Internal photos

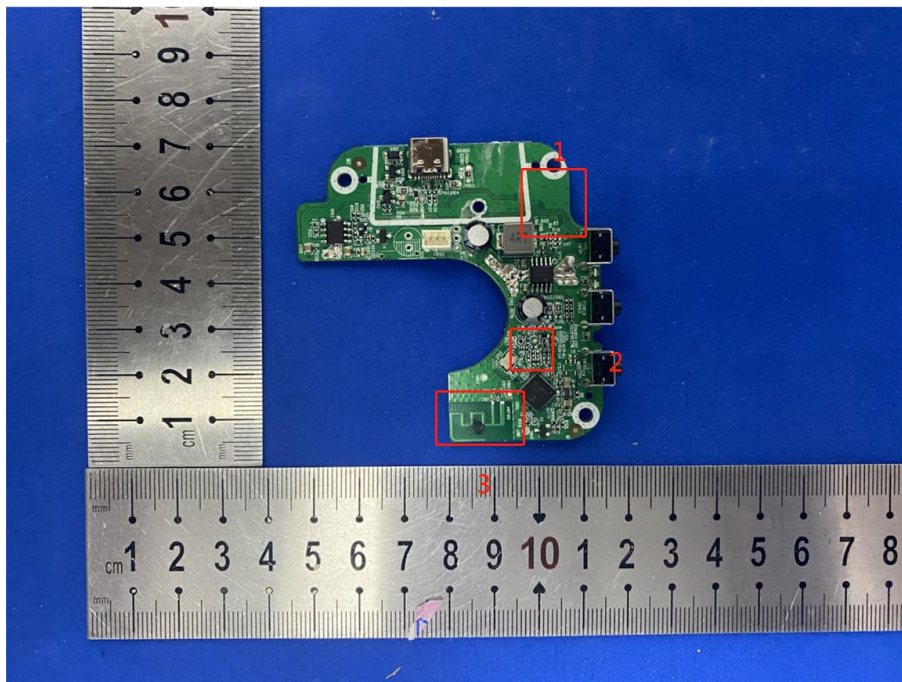
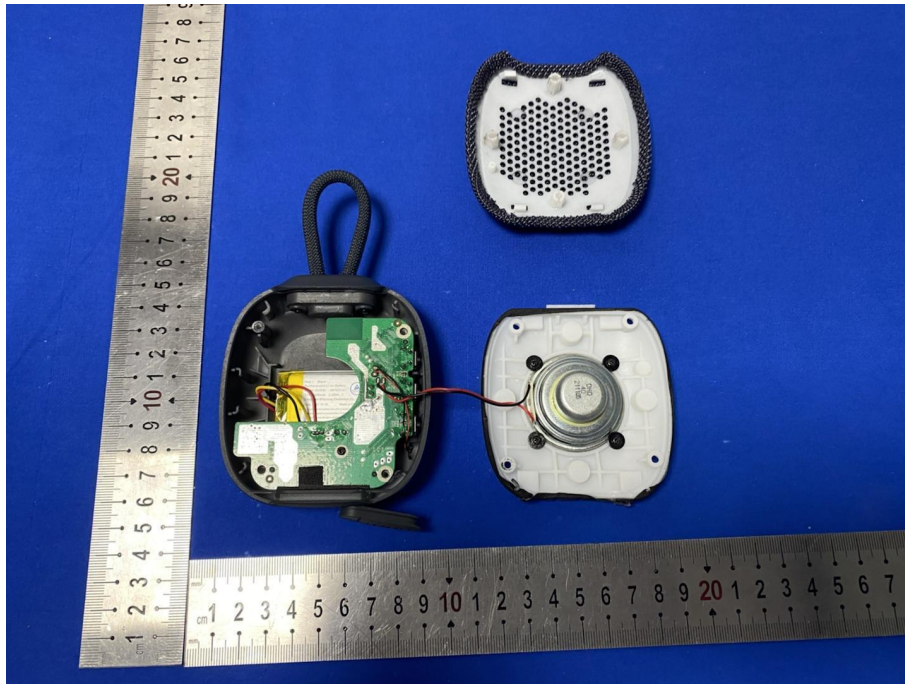
The solder joint test was cancelled at position 1, the line layout was optimized at position 2, and the antenna was lengthened at position 3

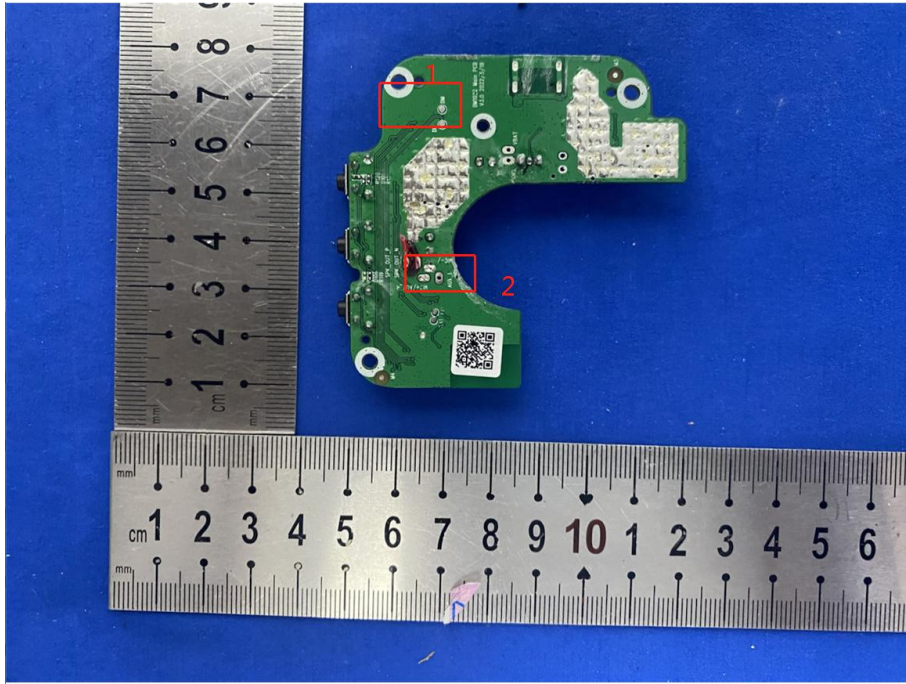
The solder joint test was cancelled at position 1, and the line layout was optimized at position 2
